**North Rockland High School Projects – Phase 2**

**MSA File No. 43045**

**NOTICE TO BIDDERS**

Re: **ADDENDUM NO. 1**

CE-504

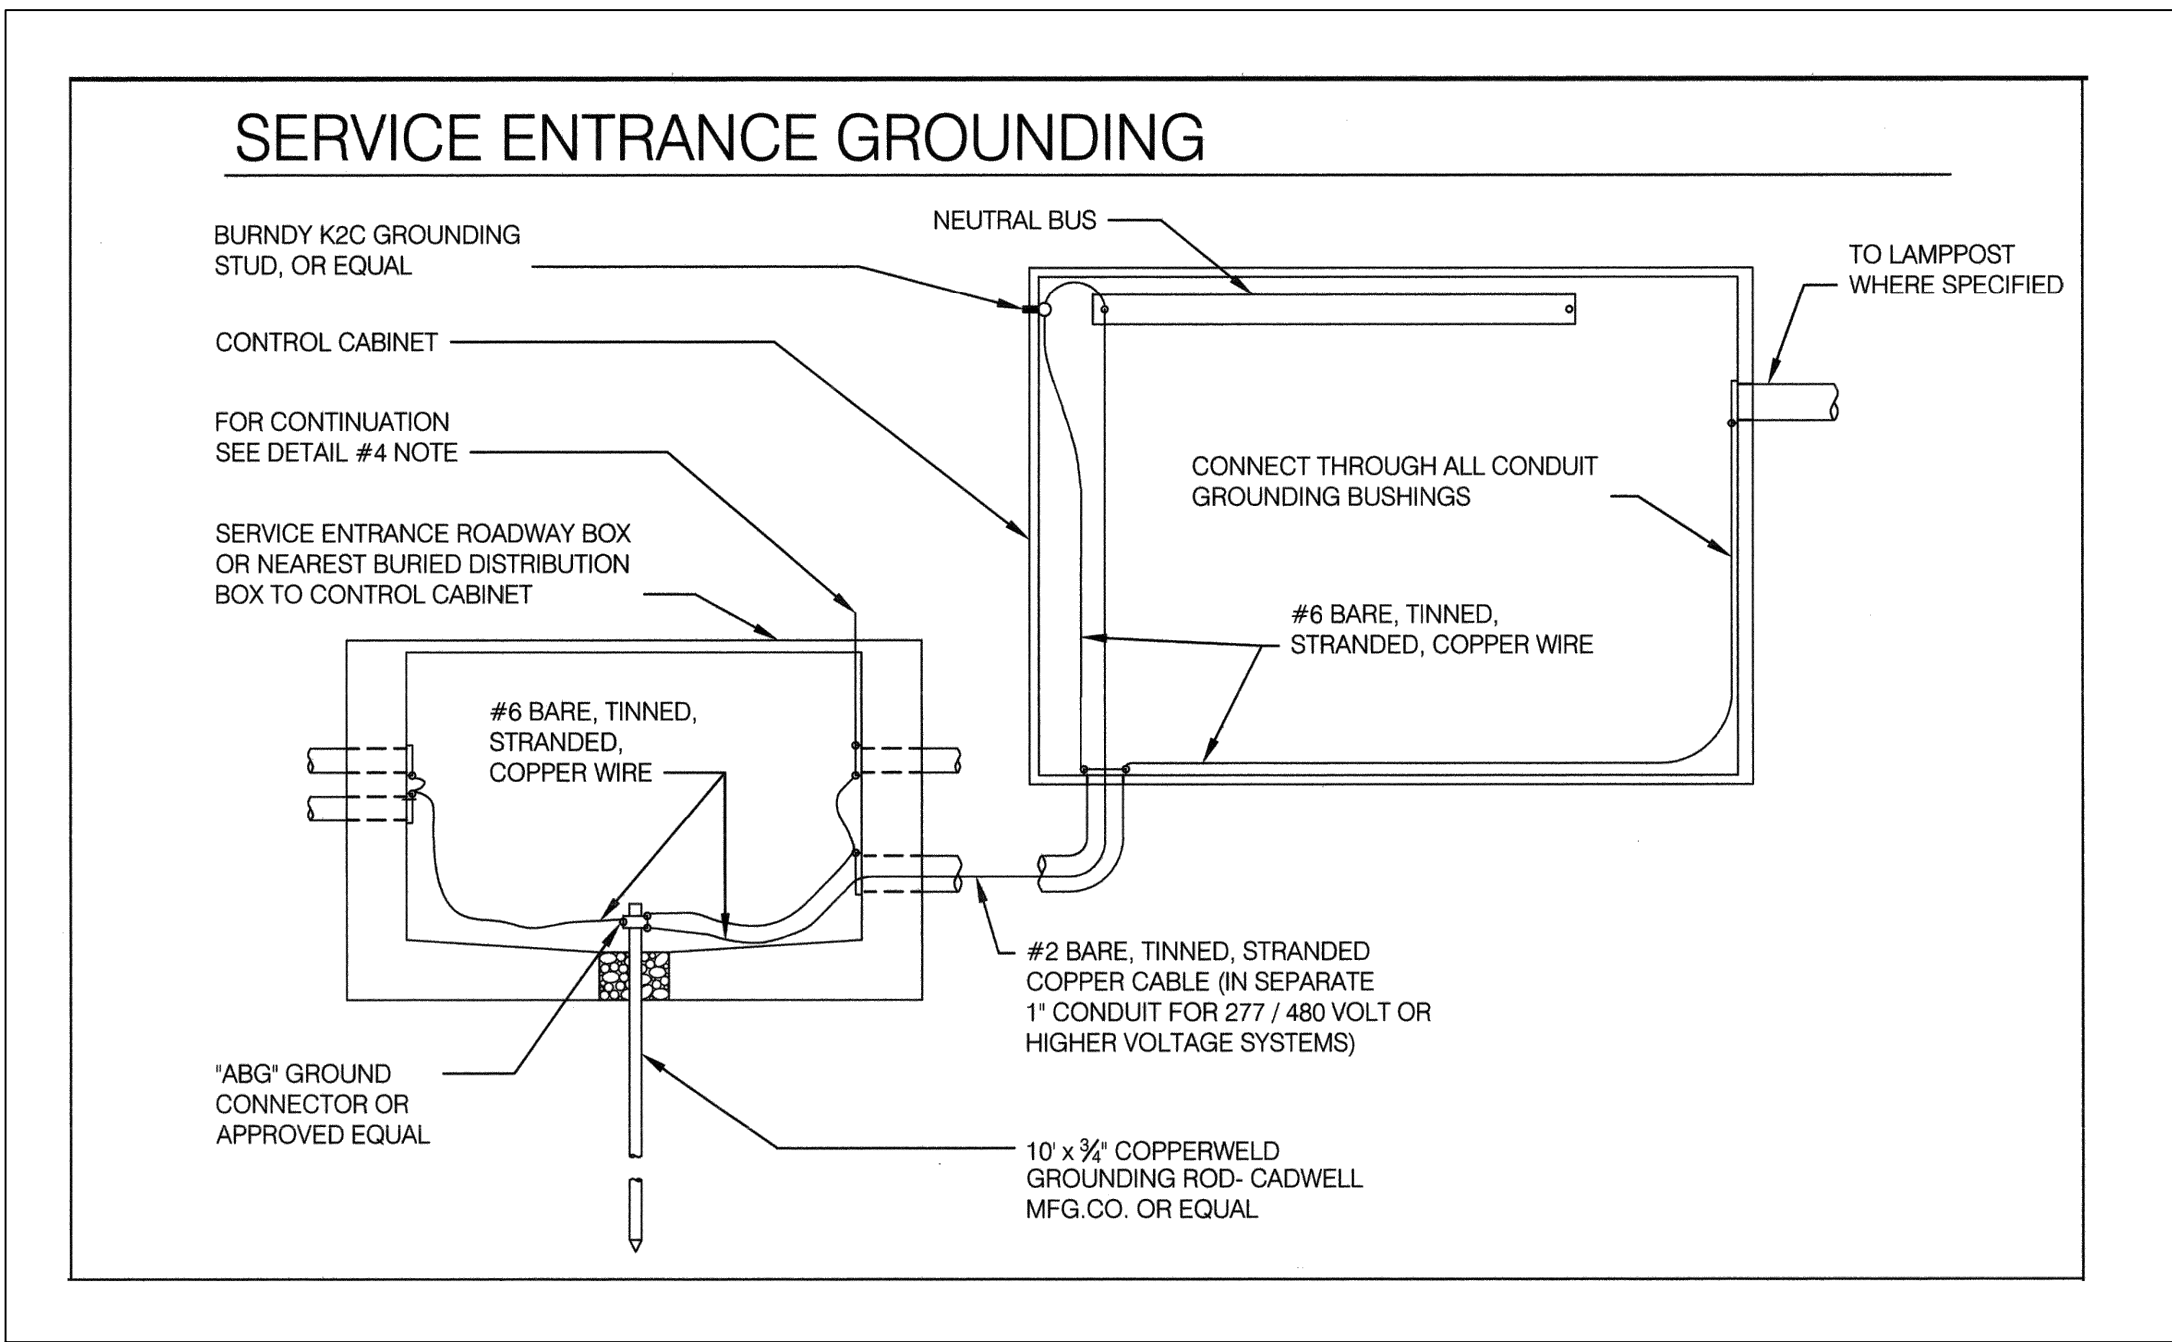
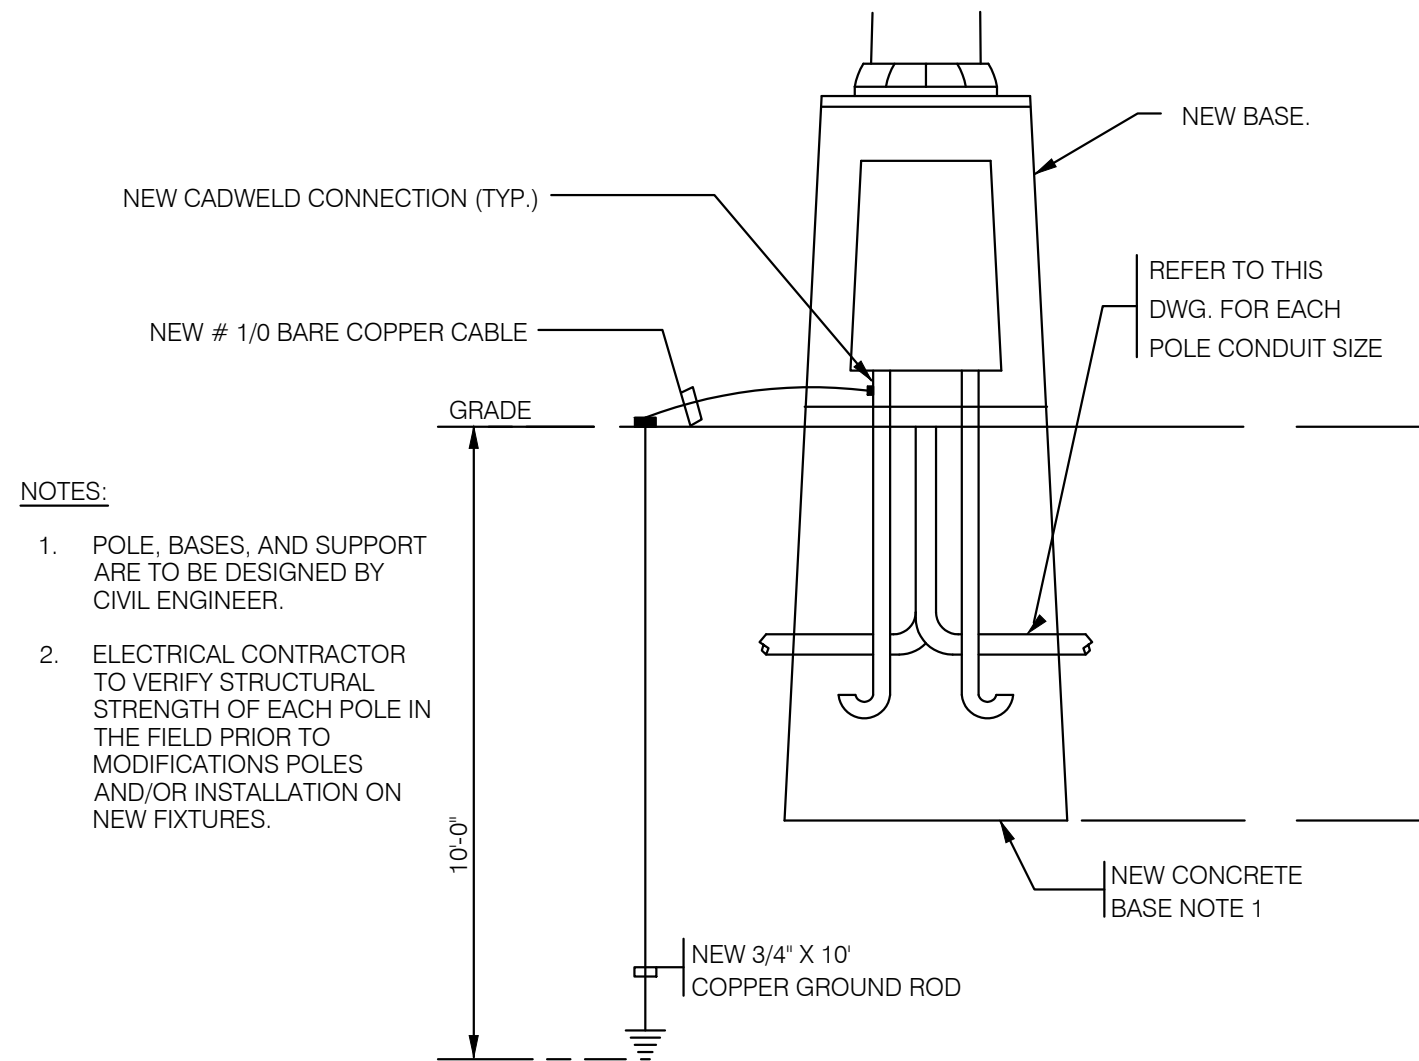
11) See attached revised drawings CE-102, CE-103, CE-501, CE-502, CE-503, CE-504 and CE-505 for updated sound system, controls and grounding detail.

**M-102**

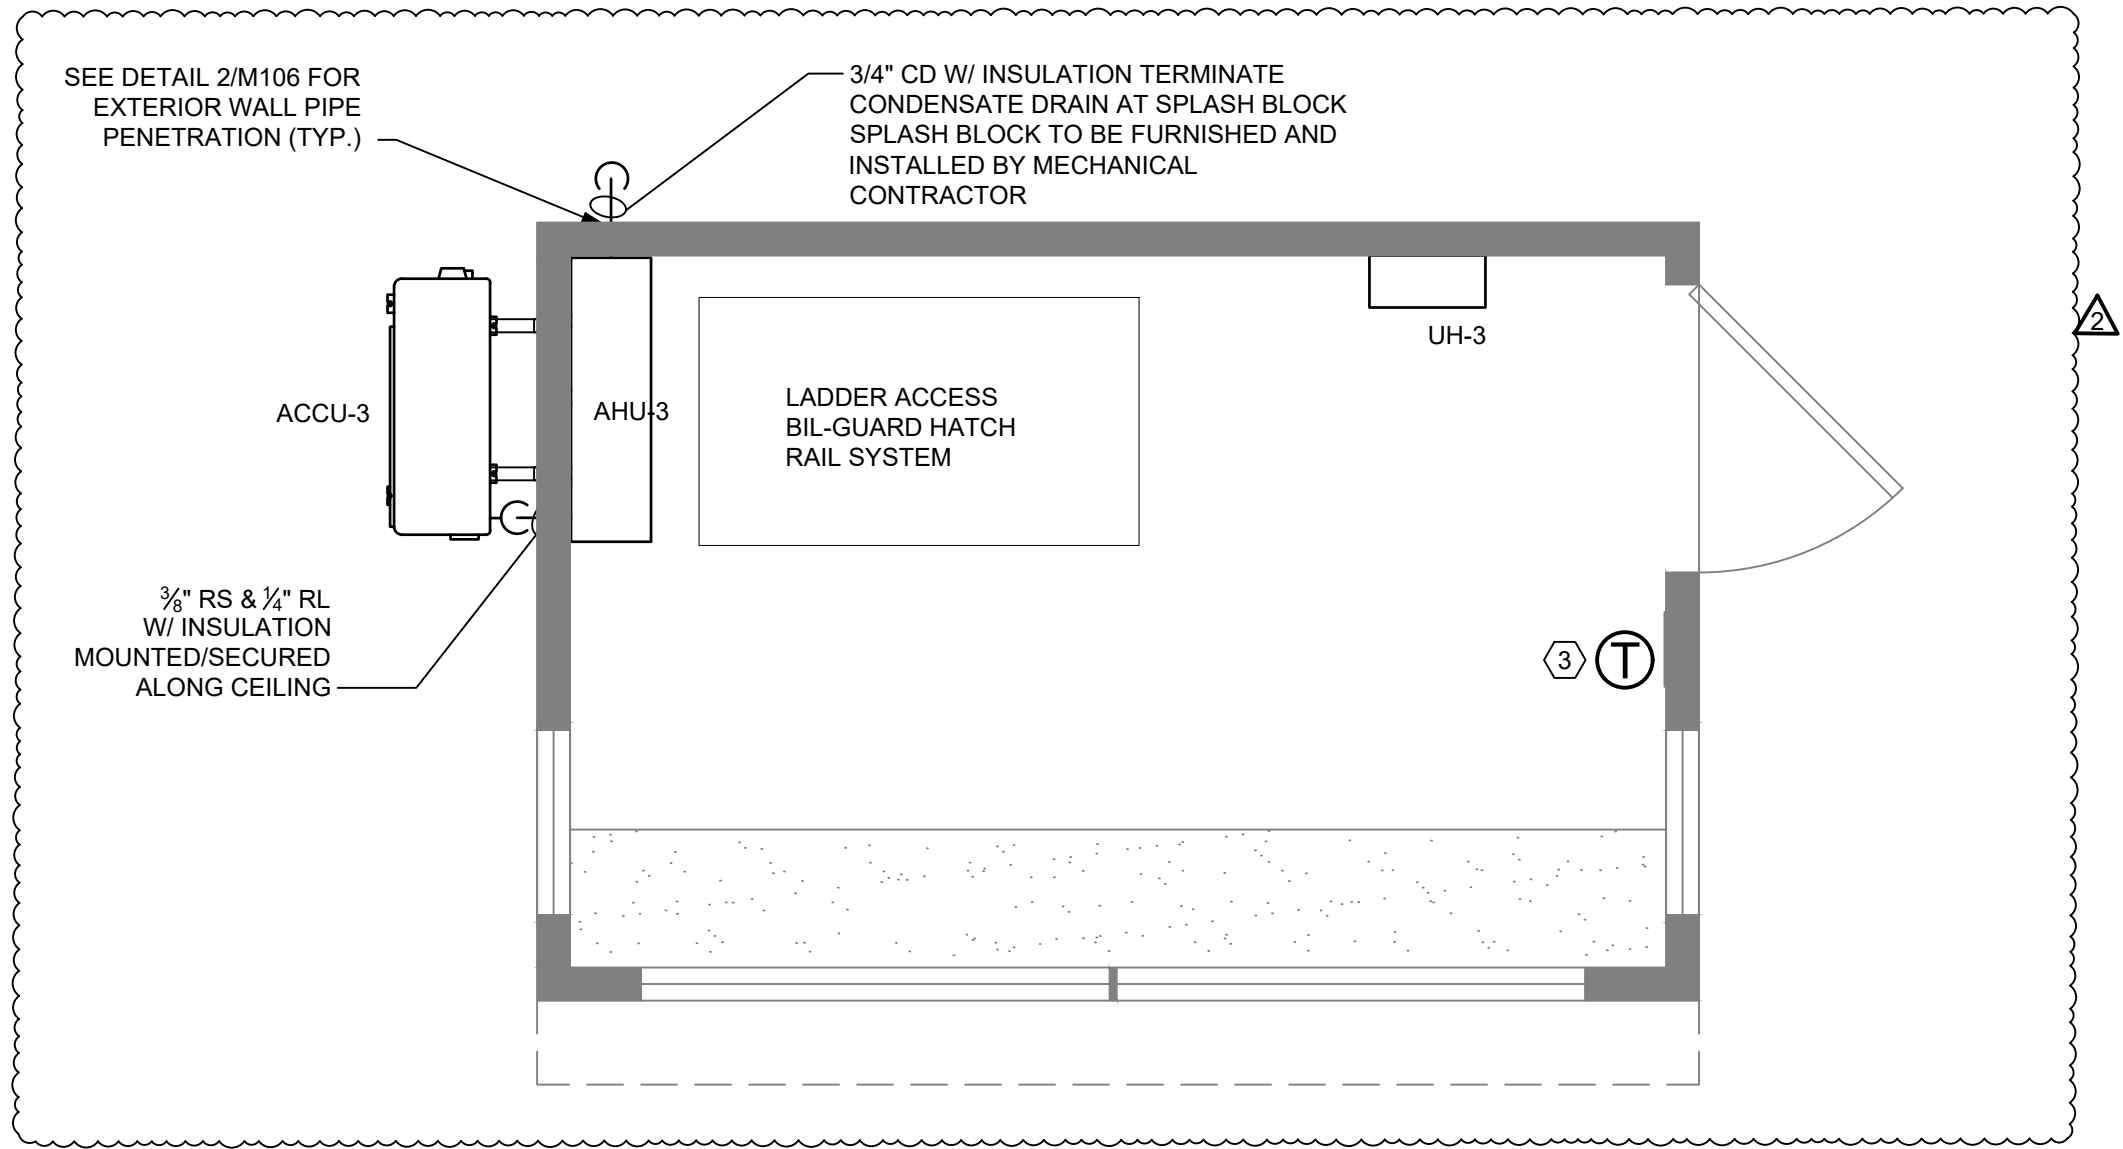
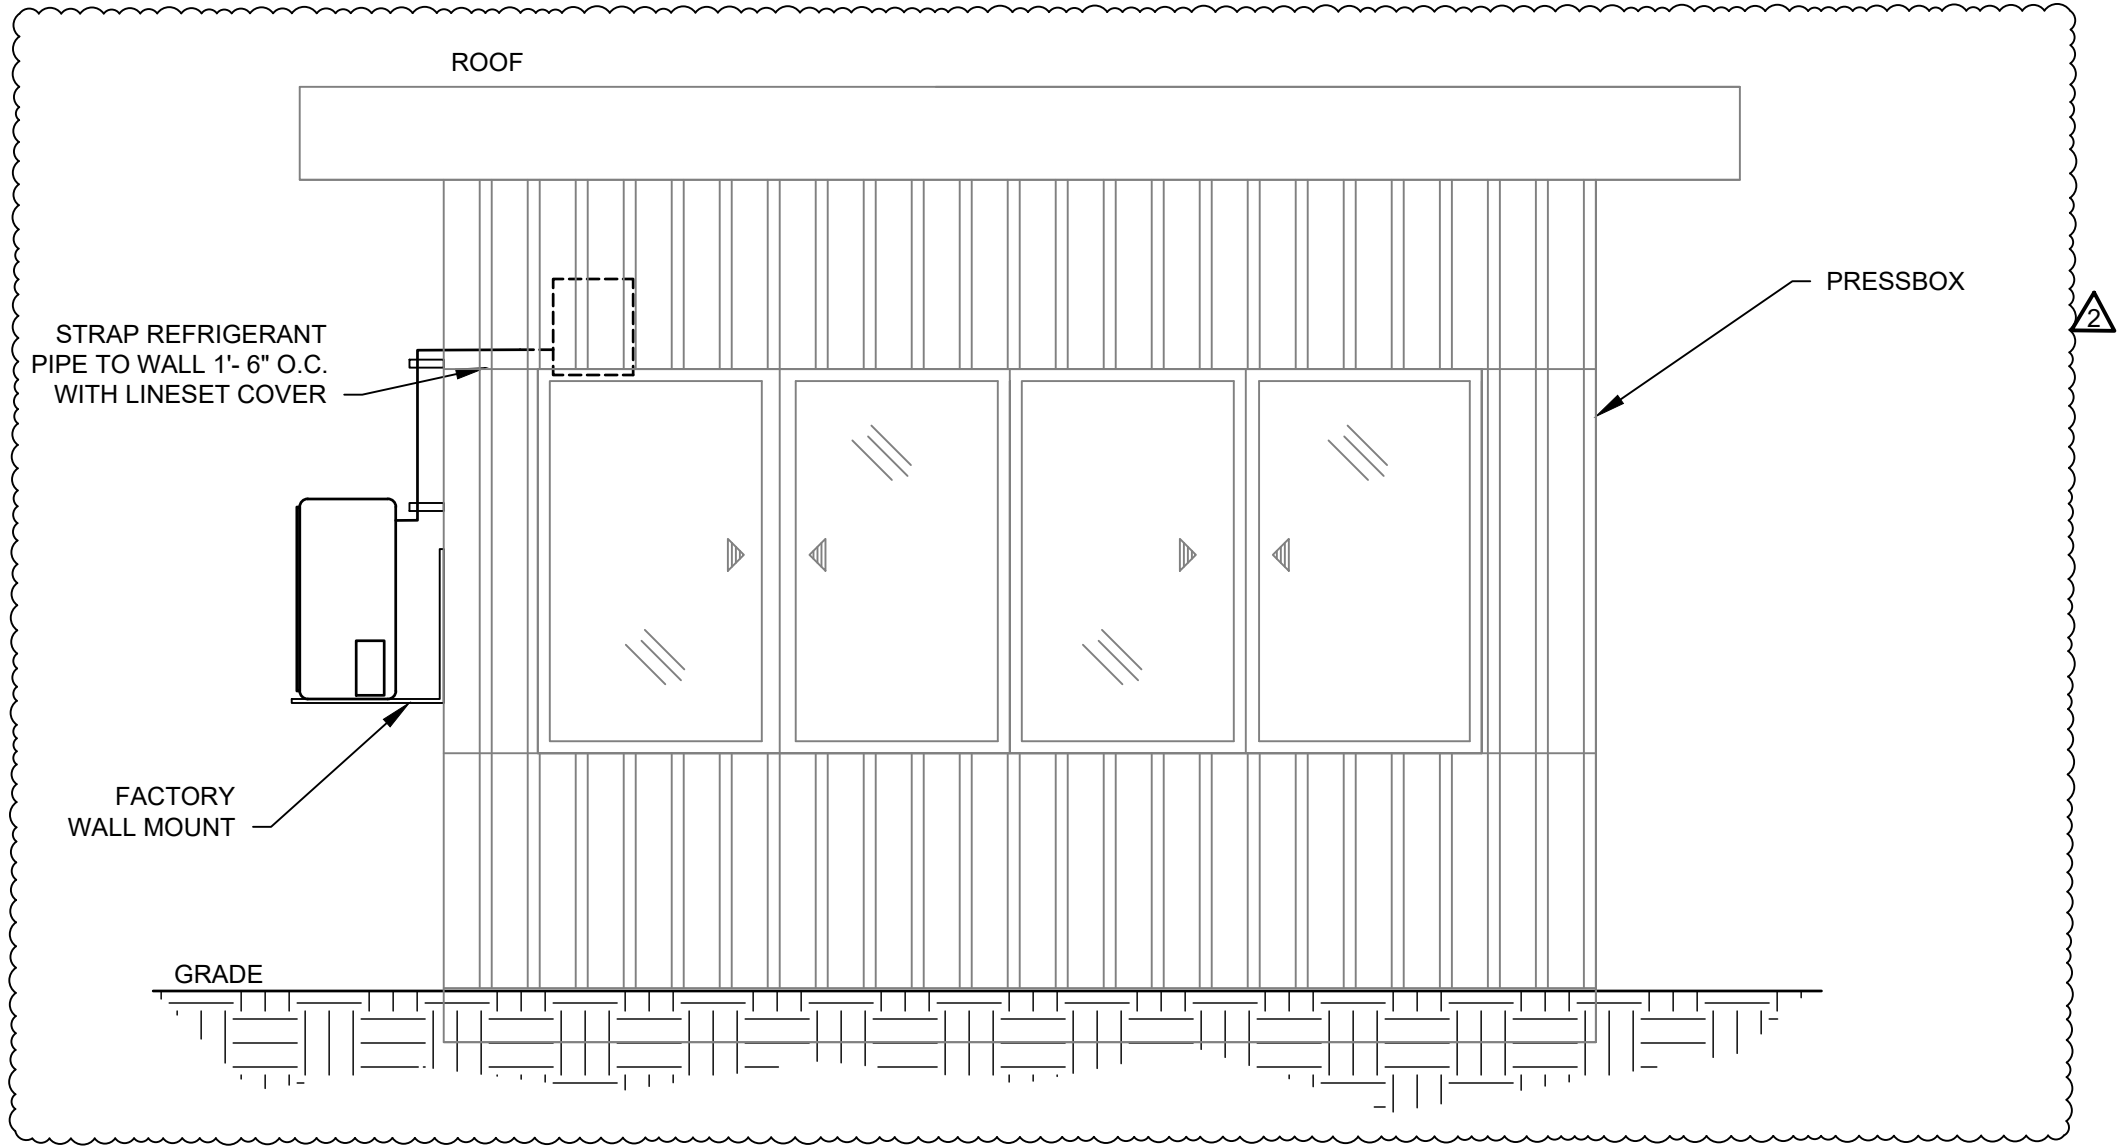
14) See attached revised drawing M-102, M-103 and CE-106. Plans and elevations of Press Boxes have been revised to match as shown in Architectural Drawings.
